Norp Knit Industries Ltd.

Unit- 02 (Extension)

R.I Park, 93, Islampur,Kodda, Nandun, Gazipur 1700
(23.985522, 90.353672)
17 September 2023

Observations

Design report: Value of response modification factor R = 8

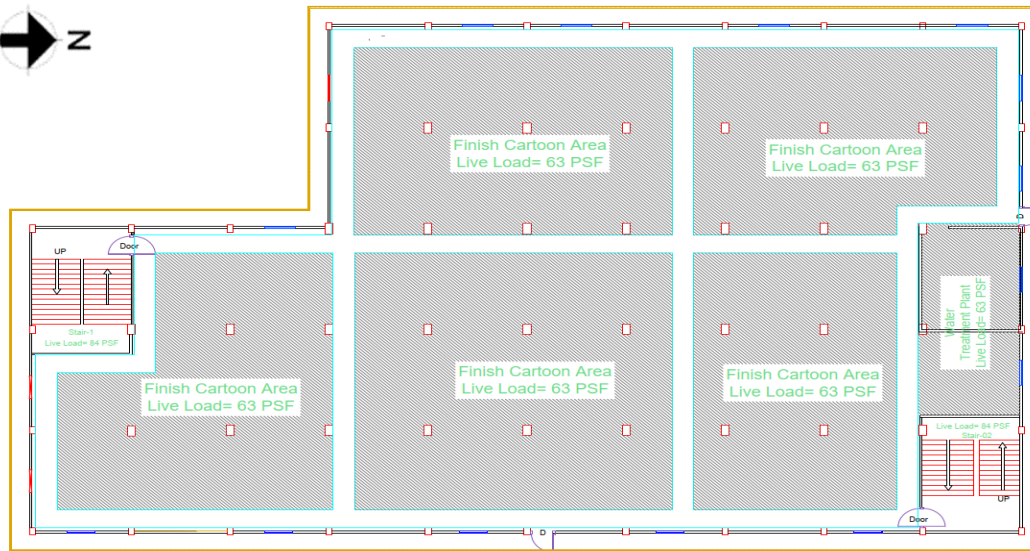
The structural framing system is considered as IMRF, and value of response modification factor R is considered as 8. However, no supporting calculation is provided for it. Building engineer is required to provide supporting calculation for R=8 as per 8.3.10 of BNBC.

3RD FLOOR LOAD PLAN

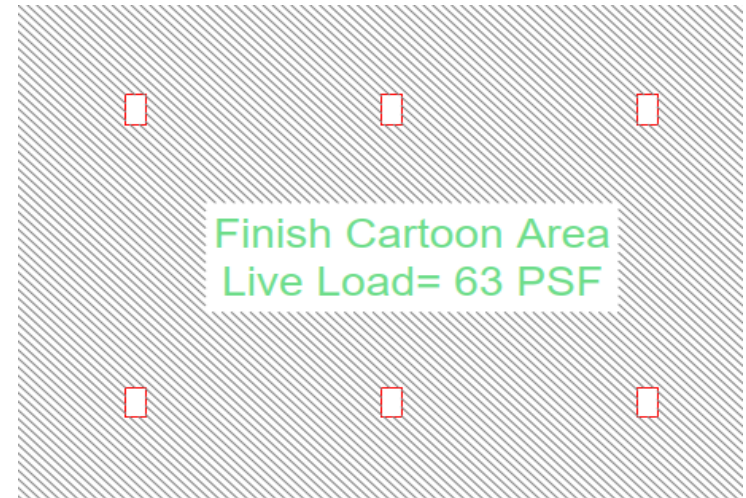
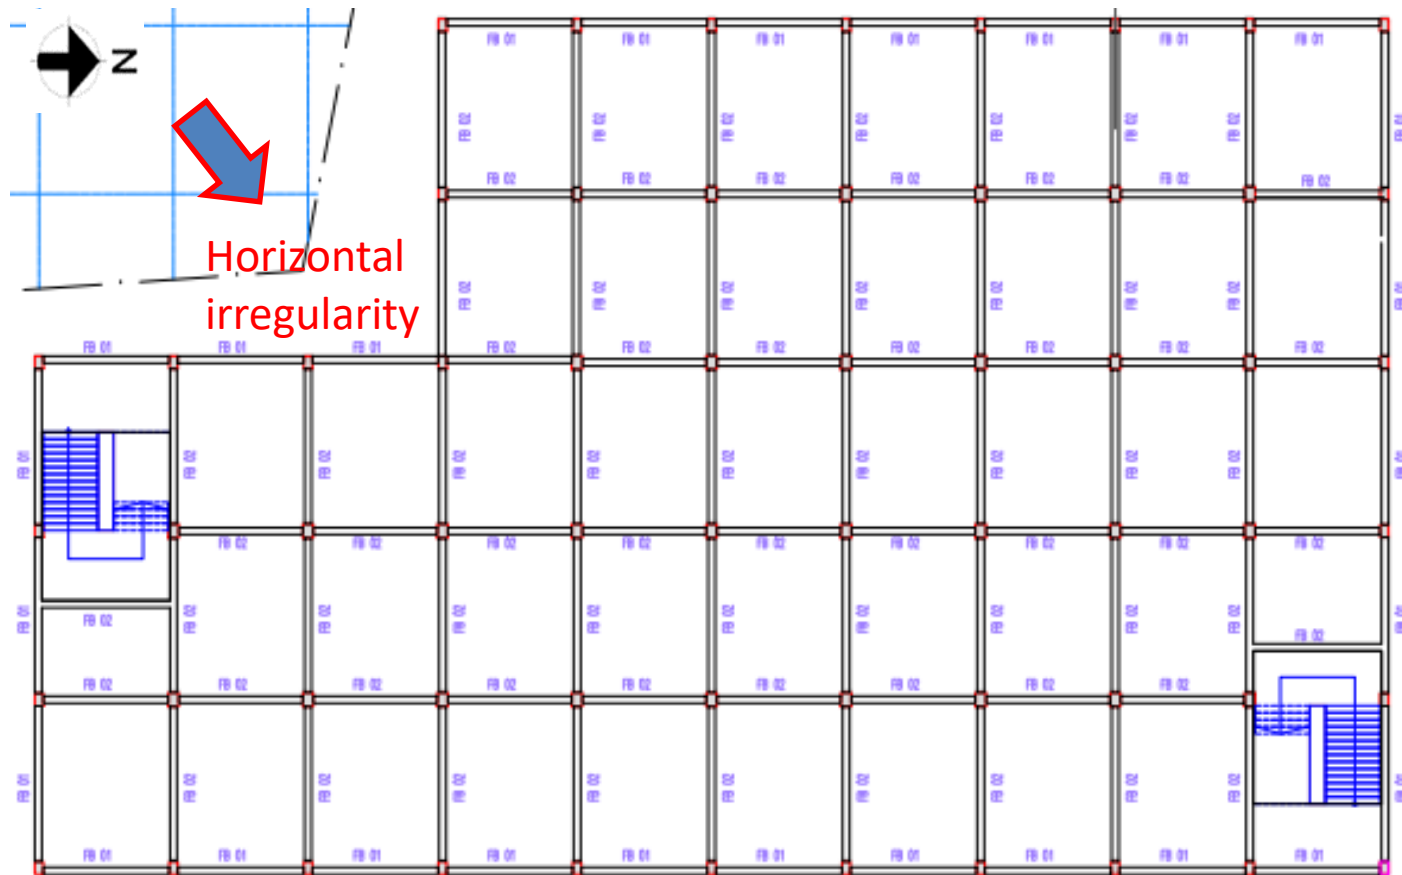
Live load on typical floor is considered as 3 kPa in prepared load plan. As per BNBC- Part 6, live load for light storage areas is required to be considered minimum 6 kPa. However, the factory engineer is required to revise the load plan as per BNBC requirement and check the design accordingly.

Apparently inadequate connection

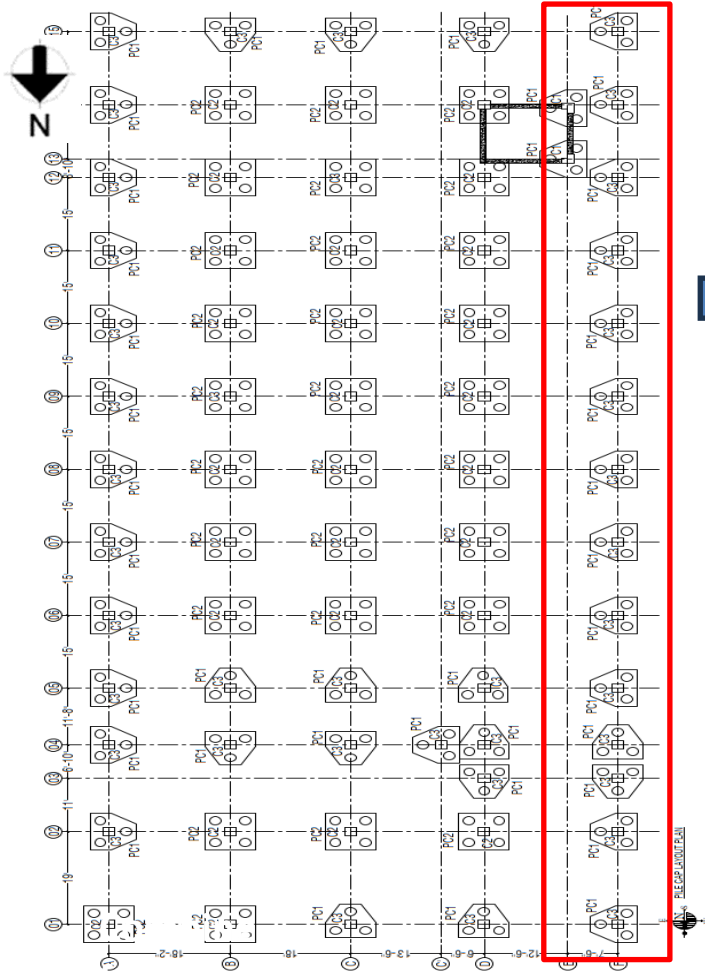
Rafter of stair roof was found inserted to brick wall which was appeared to be inadequate. Building engineer is required to check the connection adequacy for uplift forces.
